From: Sofie Fieldsend
Sent: 04 May 2021 09:05
To: Planning
Subject: FW: 2021/0706/P 5 Belsize Park Mews OBJECTION
Attachments: 5 BPM 20210706P.pdf

I would like to object to application 2021/0706/P 5 Belsize Park Mews.

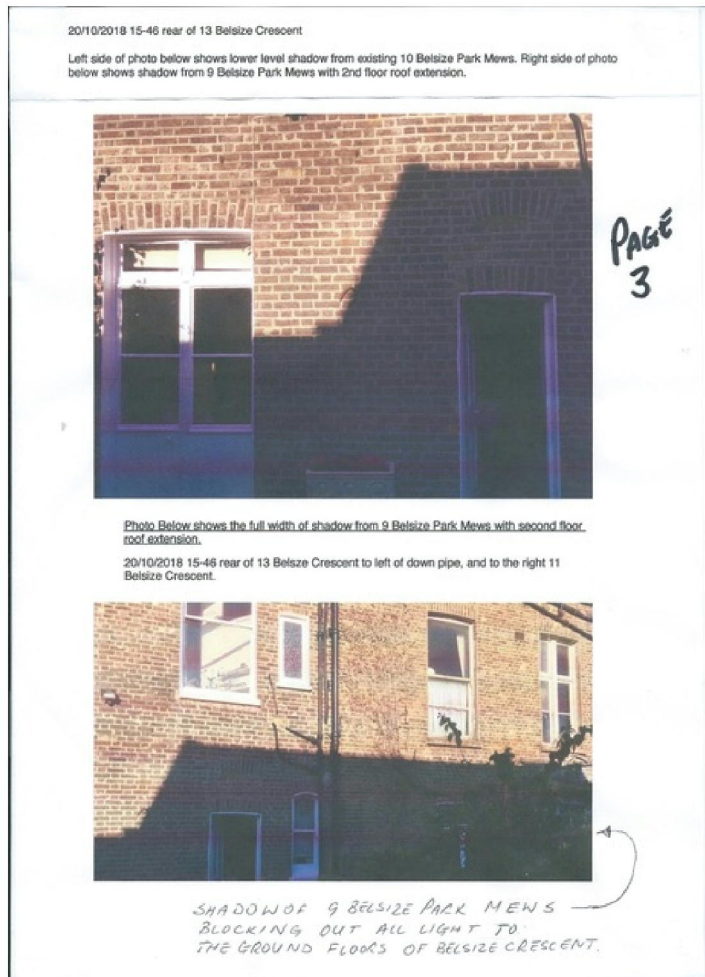
It is also clear that this application fails the 25' test by huge margins even at 6.5 metre allowing for differing ground levels between 5BPM & garden level at 5 belsize Crescent, see scaled pdf below.
